**State Project: 063-729 (Sigourney Street Bicycle Facilities)
Hartford, CT**

Subject: Response to email comments (Stakeholder follow-up from Virtual Public Information Meeting)

Responses to Tony Cherolis 3/17/2002 comments:

SIGOURNEY ST & HAWTHORN ST

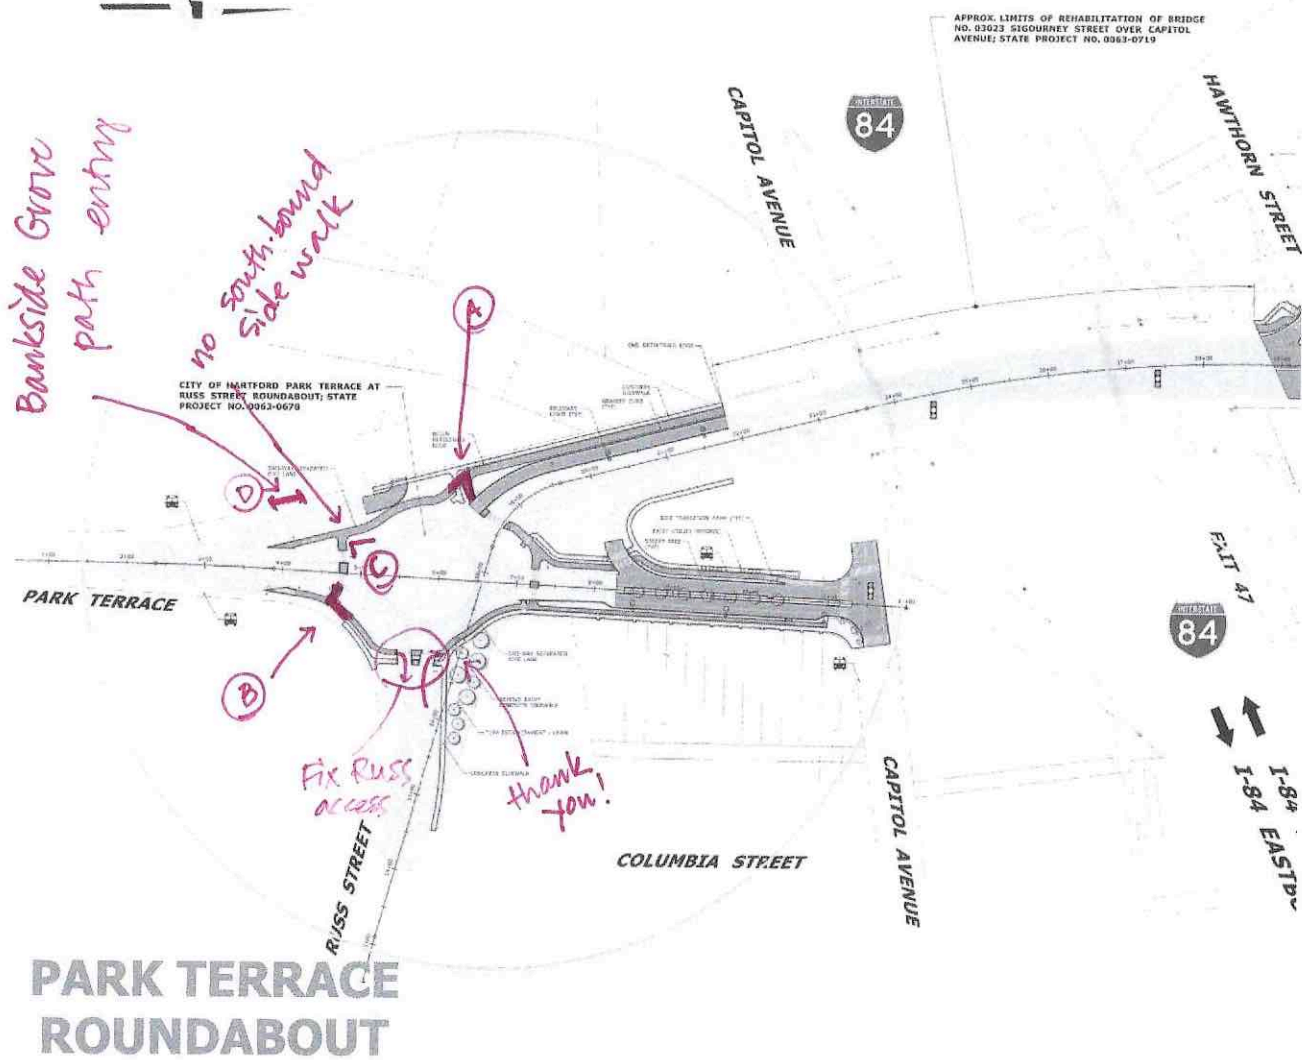
1. Two corners on the cycletrack (A and B noted on the attached map) seem oddly acute. At A, in particular, there is ample room to adjust for an easier turn. If the cycletrack is not easy to ride and well-marked, bikes will just go in the circle.

4. Please include the missing pedestrian connection © southbound at the southwest corner of the circle, and coordinate with the design of the Bankside Grove path (D) so that two bike paths do not end 15' apart with embarrassing curbs in between.

- **RESPONSE:** In general, corner radii when turning into the roundabout crosswalks meet or exceed the recommended 5' min. radius for cycle tracks (Source: MassDOT Separated Bike Lane Planning & Design Guide). At location "A", cyclists heading northbound onto Sigourney or heading southbound onto Park Terrace have an effective radius of 10-ft and 7.5-ft – right turn movements towards Park Terrace north should be fairly uncommon as it is an indirect travel path compared to the more direct counterclockwise route. At location "B", the effective turning radius is 10-ft for cyclists traveling northbound or eastbound. Additionally, the one-way cycle track 7-ft width provides additional buffer space when making turns. As design develops, the project team will continue to refine corner radii (factoring in safety, usability, and site constraints).

- **RESPONSE:** The project team will investigate and incorporate a connection with the Bankside Grove path. We agree that a more direct sidewalk connection across the Pope Pump Station driveway will better align with user's desire lines and overall pedestrian network.

Sigourney St & Farmington Ave

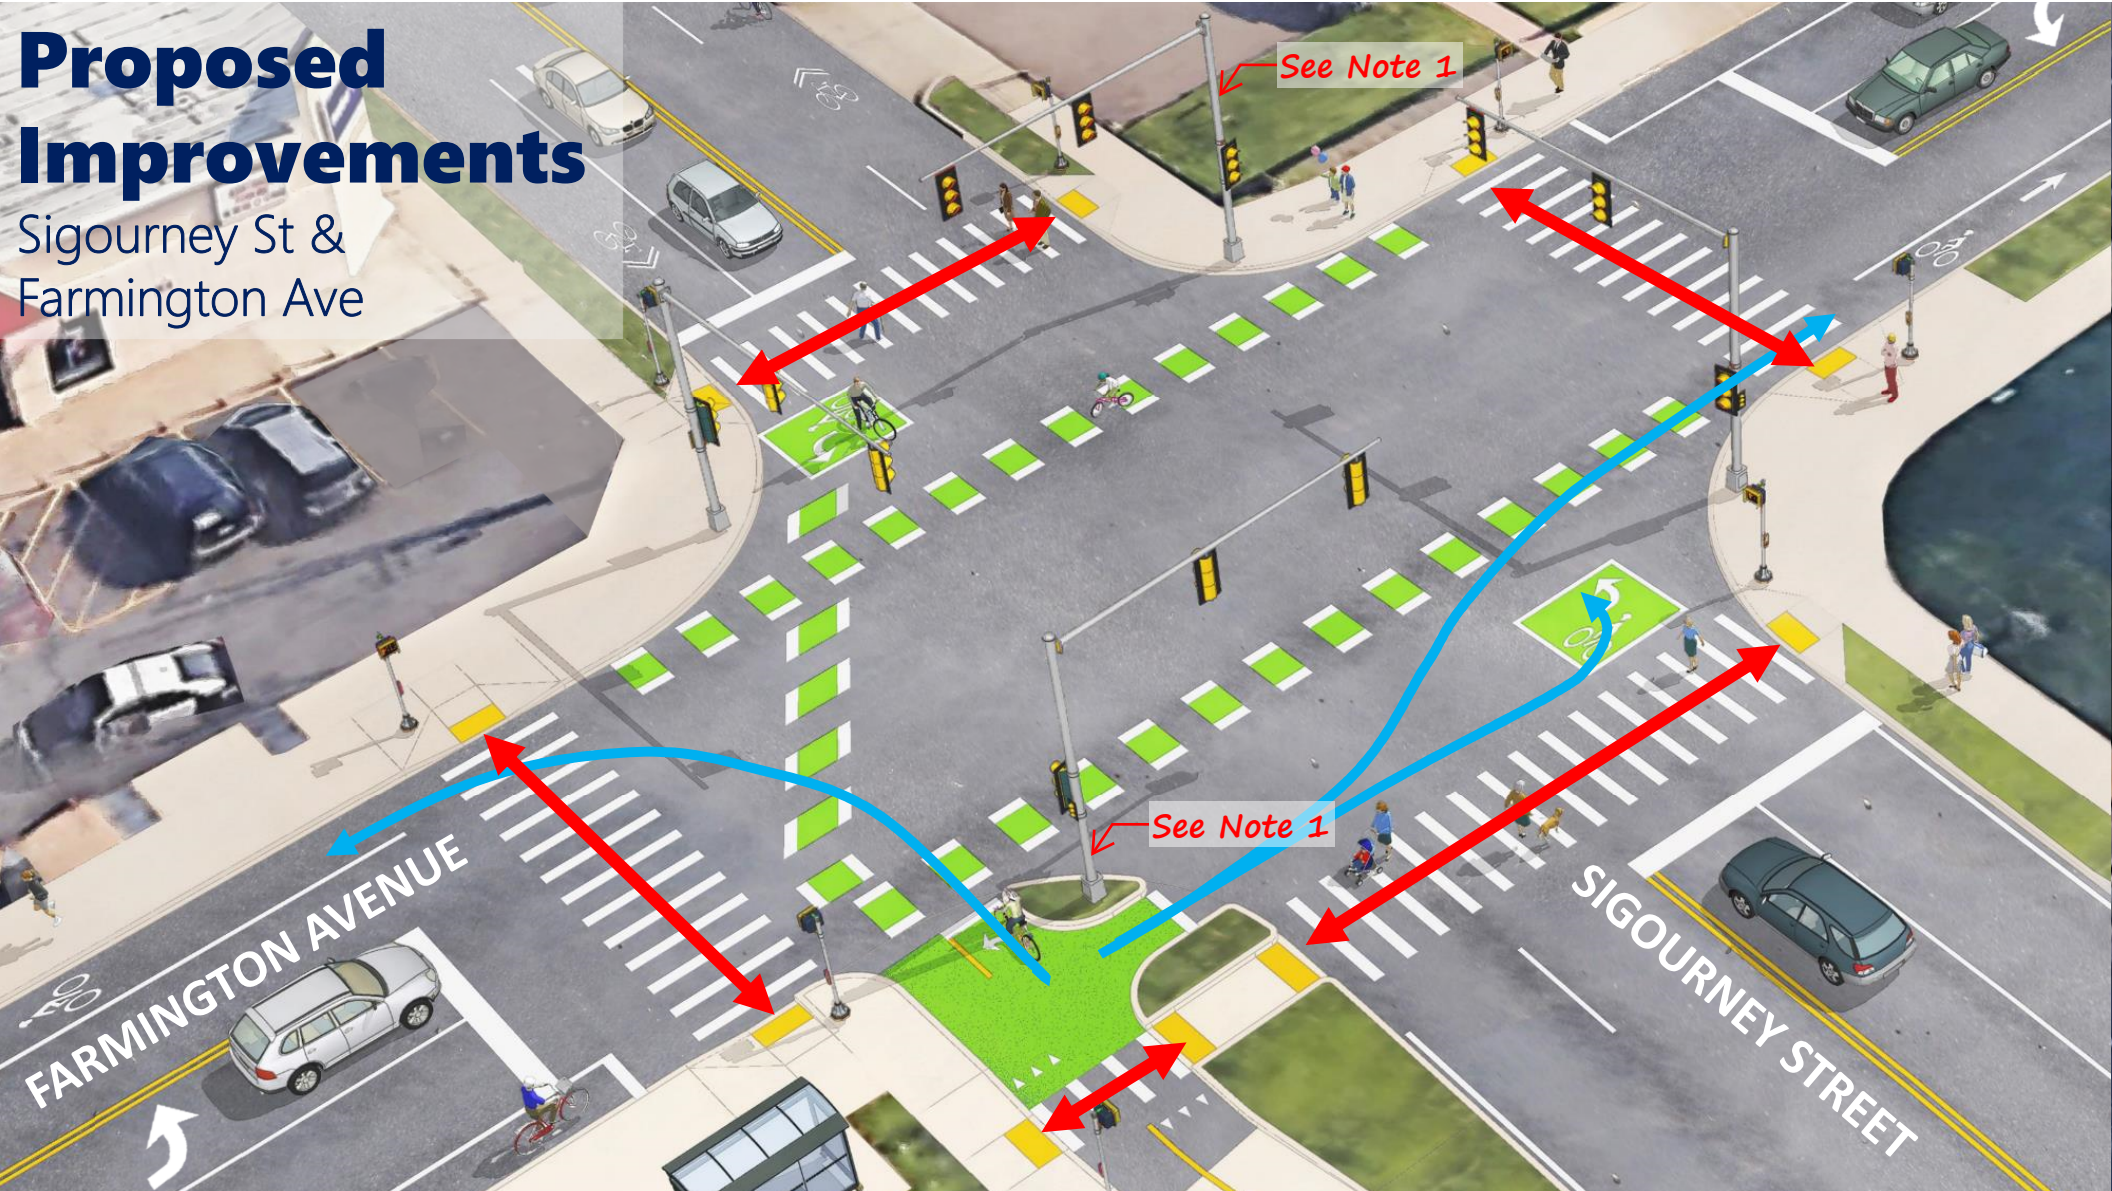
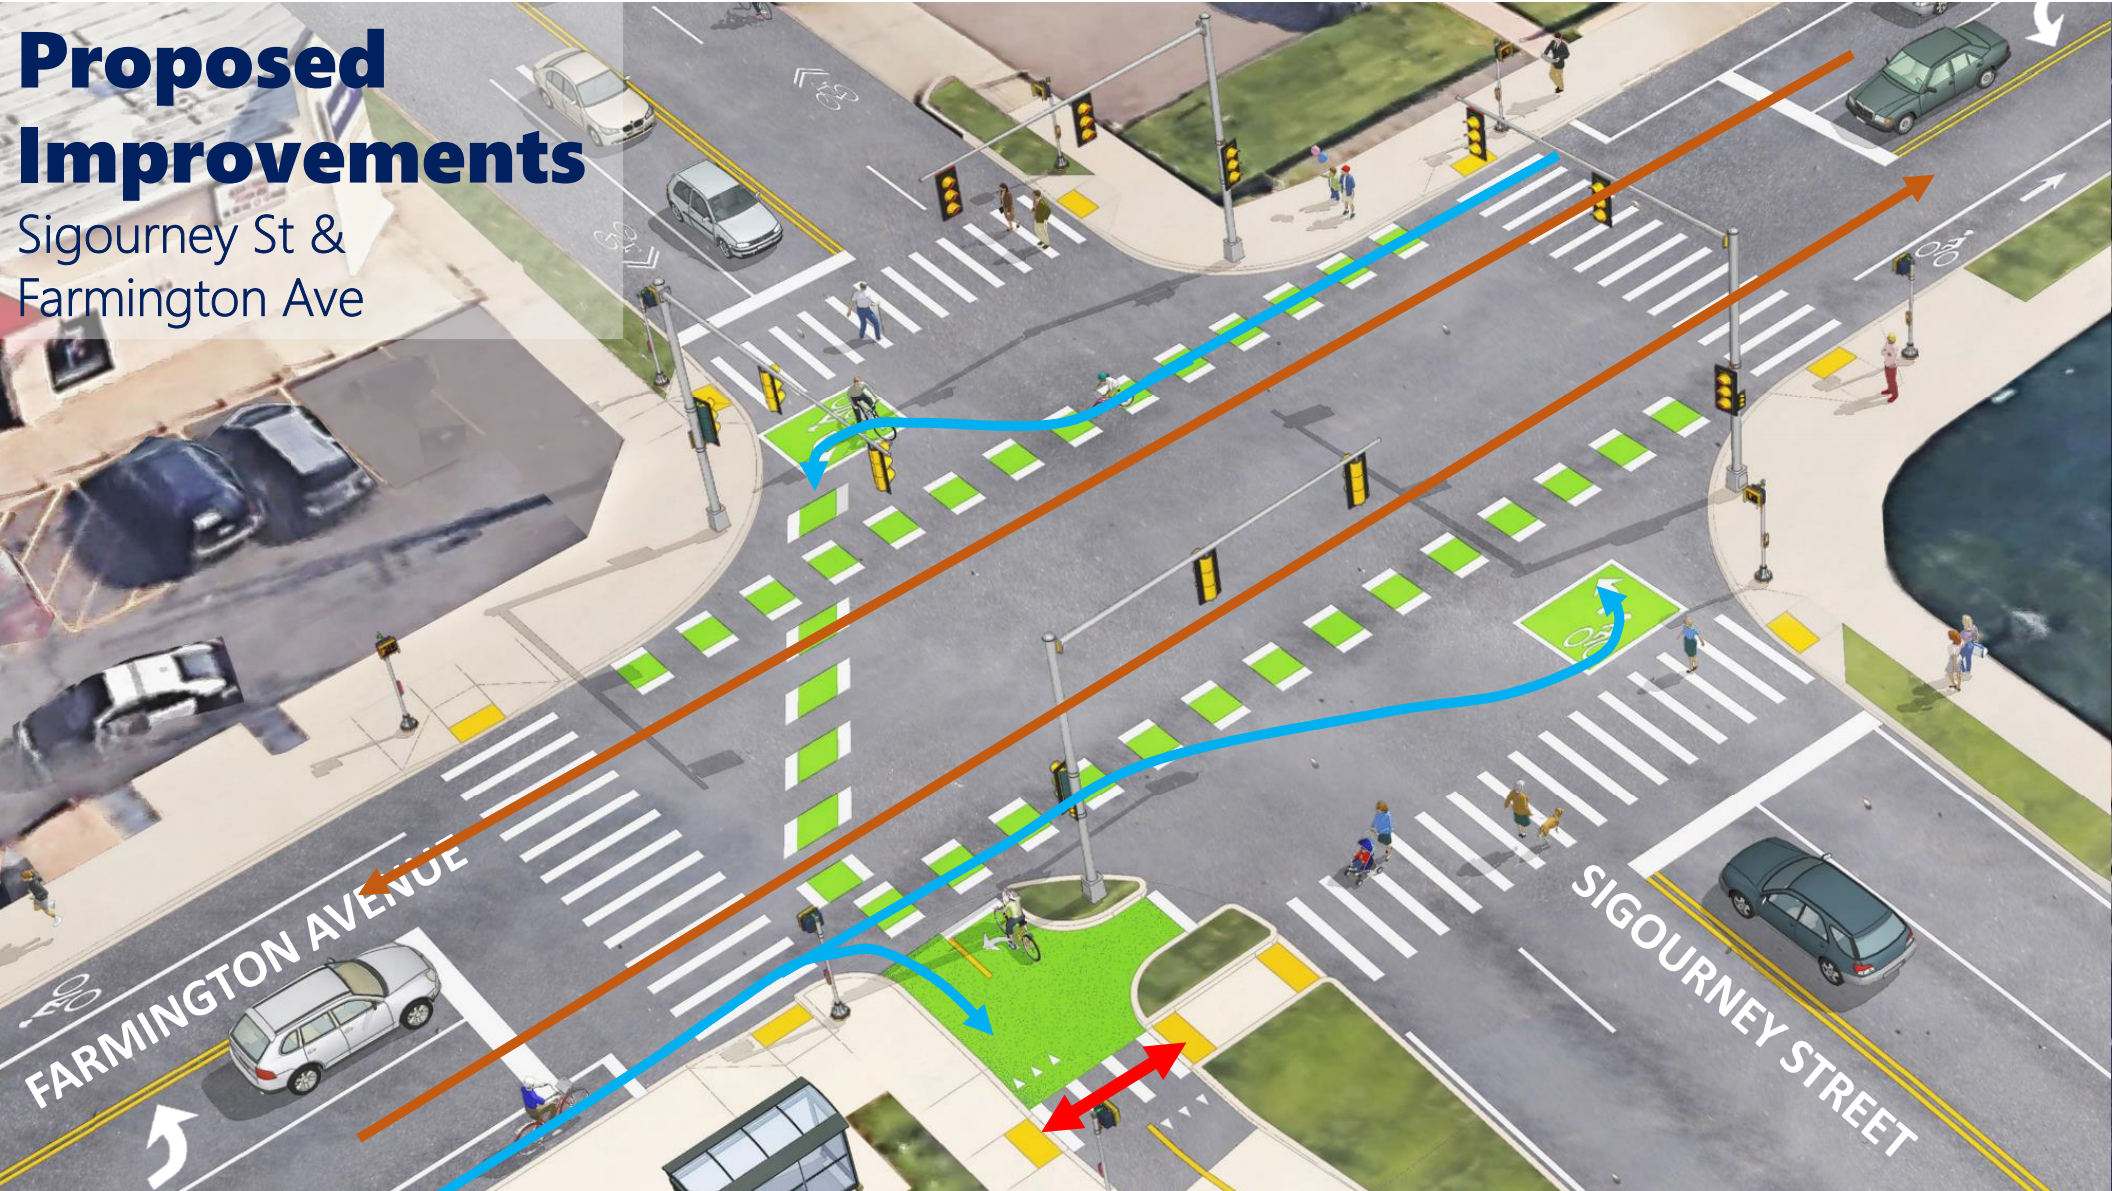
- 5) I don't think I can get my head around the redesign of the Sigourney and Farmington Ave intersection until I get there myself after construction.
 - **RESPONSE:** Please refer to the attached movement diagram illustrating the various cyclist movements at the Sigourney-Farmington intersection. The design intent is for a cyclist heading northbound on Sigourney Street (on the two-way cycle track) to wait with pedestrians until the traffic signal activates an all-stop phase for vehicles and both pedestrians and cyclist would navigate through the intersection. We also are planning on using intersection and advanced image detection cameras that are capable of picking up bicycles along a dedicated bike path.

6. Similarly, access to and from the cycletrack at Farmington remains confusing to me—I can't quite imagine how it's supposed to flow. Signage here will also be critical.

- **RESPONSE:** Please refer to the attached movement diagram illustrating the various cyclist movements at the Sigourney-Farmington intersection. The design intent is for a cyclist heading northbound on Sigourney Street (on the two-way cycle track) to wait with pedestrians until the traffic signal activates an all-stop phase for vehicles and both pedestrians and cyclist would

navigate through the intersection. We also are planning on using intersection and advanced image detection cameras that are capable of picking up bicycles along a dedicated bike path.
